Subject: Supplemental Information Regarding License Amendment Application to Increase Allowable Power
(License Amendment Request No. 00-0006; TAC No. MB3280)

SUPPLEMENTAL INFORMATION
IN SUPPORT OF THE
APPLICATION FOR AMENDMENT
TO
FACILITY OPERATING LICENSE NPF-3
DAVIS-BESSE NUCLEAR POWER STATION
UNIT NUMBER 1

RESPONSE TO REQUESTS FOR ADDITIONAL INFORMATION
REGARDING
LICENSE AMENDMENT REQUEST (LAR) 00-0006
FOR
DAVIS-BESSE NUCLEAR POWER STATION
UNIT NUMBER 1

Figure 2-1. Detailed Davis-Besse Station Power Flow Results (942MW).

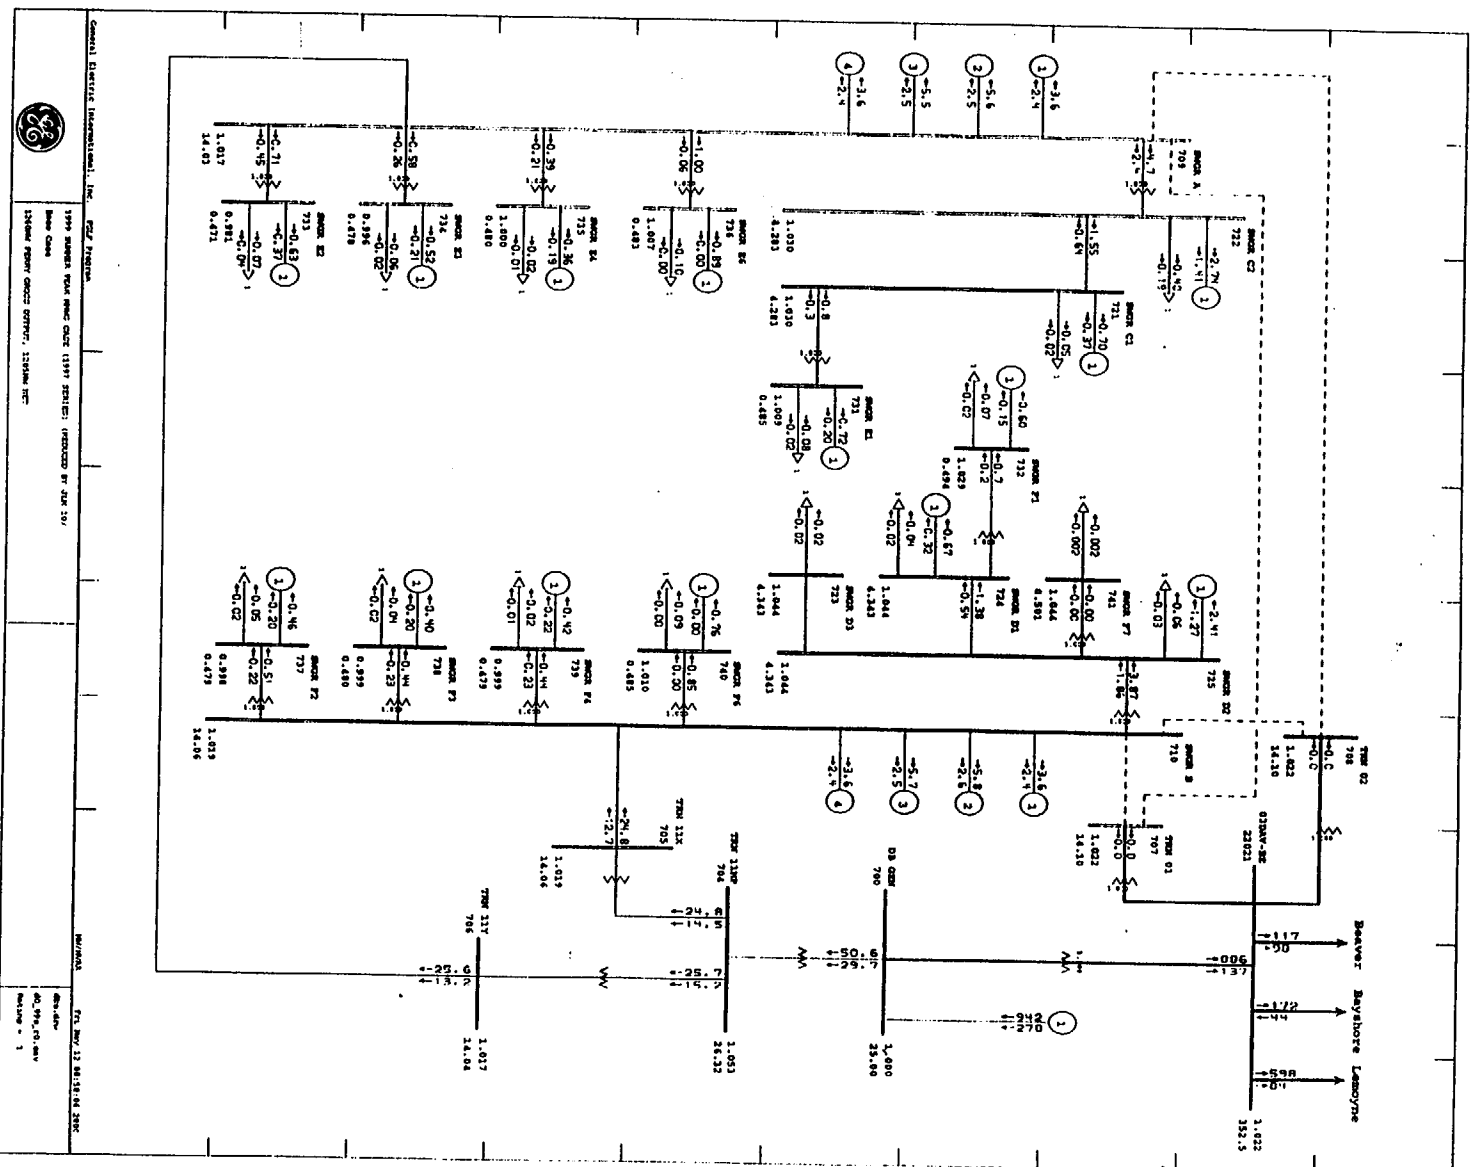
Provide the grid stability analysis performed in May 2000 for power uprate.

- The 25/13.8kV generator auxiliary transformer, which serves the auxiliary load under normal operating conditions, was modeled as a 69MVA transformer with a 0.063pu impedance (on 26MVA). The auxiliary load in the Davis-Besse plant was represented by a detailed model as shown in *Figure 2-1*.
